| 1 | 6/26/26 | ADDENDUM #01 |

**ST JOHNS CENTER**  
BYRNE HALL RENOVATION  
2417 TYLER ST  
LITTLE ROCK, AR 72207

EXTERIOR ELEVATIONS

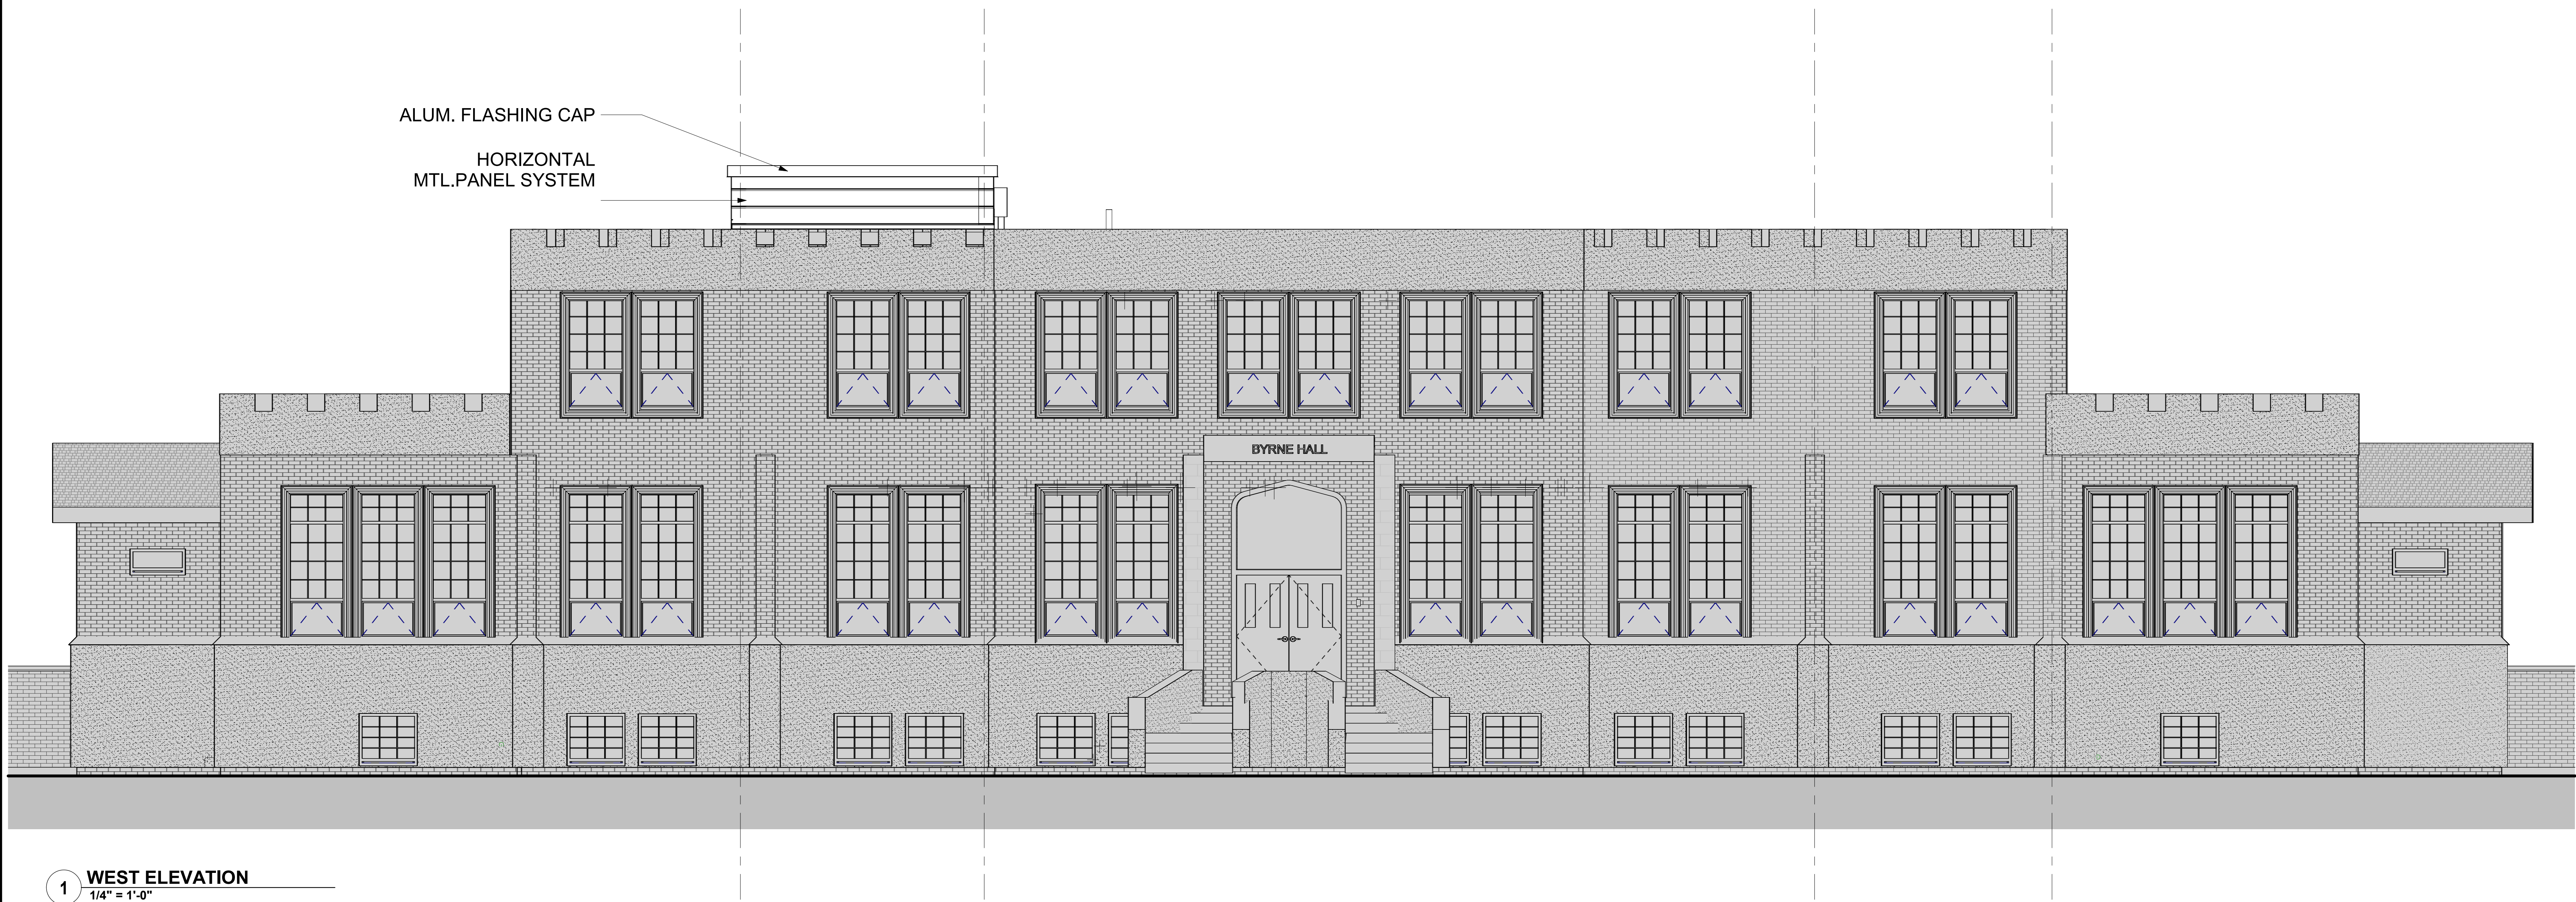
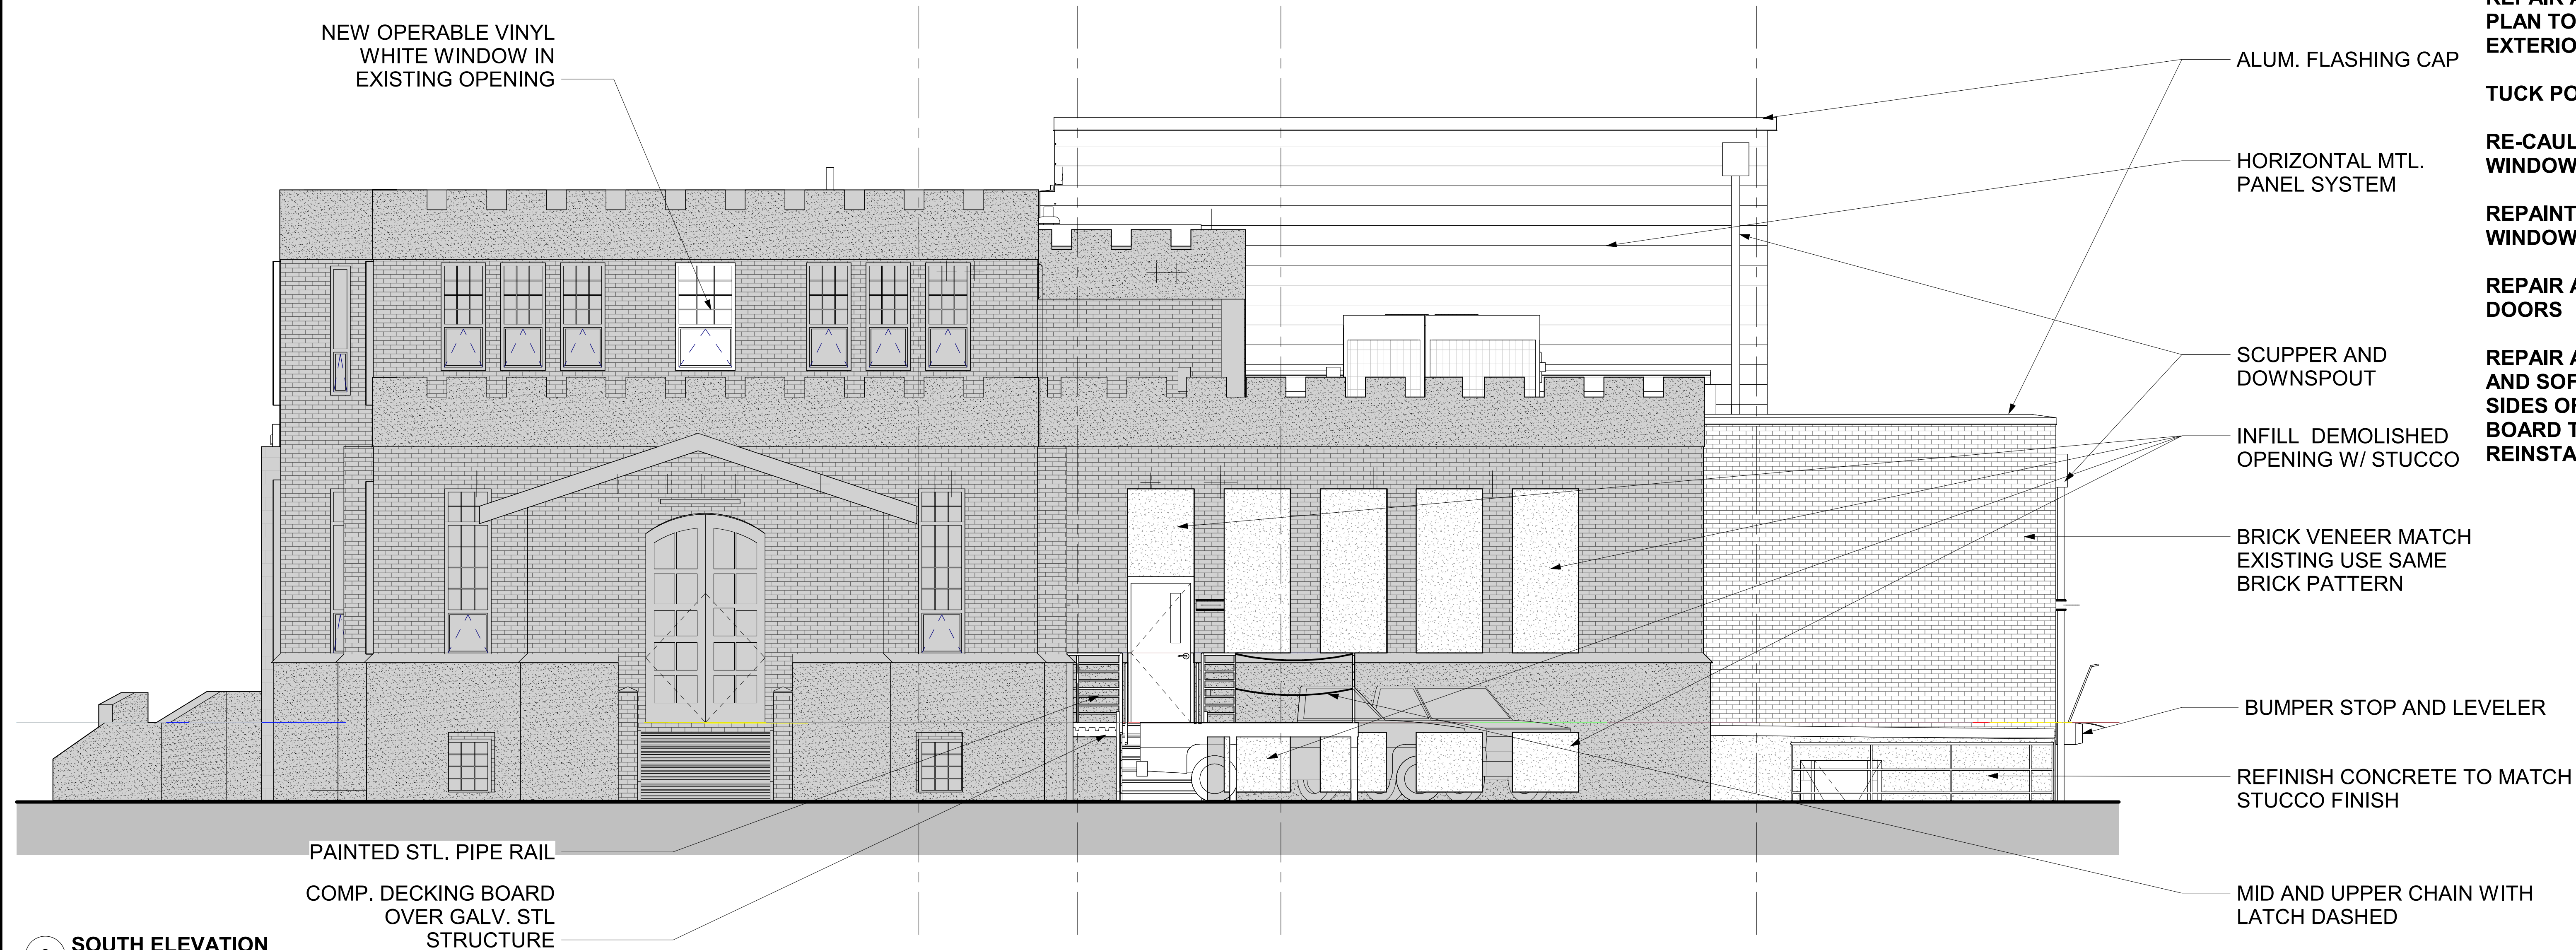
**GENERAL NOTE:**

**CLEAN AND RESEAL ALL EXTERIOR STONE, BRICK, AND PRECAST**

**REPAIR ANY LOOSE BRICK 100 SF AND PLAN TO TUCK POINT 500 SF AREA OF EXTERIOR BRICK**

**TUCK POINT 600 SF OF INTERIOR BRICK**

**RE-CAULK AROUND ALL EXTERIOR WINDOWS AND DOORS**

**REPAINT ALL EXTERIOR EXISTING WINDOWS**

**REPAIR AND REPAINT ALL EXTERIOR DOORS**

**REPAIR AS NEED AND REPAINT FASCIA AND SOFFIT AT NORTH AND SOUTH SIDES OF BUILDING. ADD FASCIA BOARD TO SUPPORT THE GUTTER, REINSTALL GUTTER**
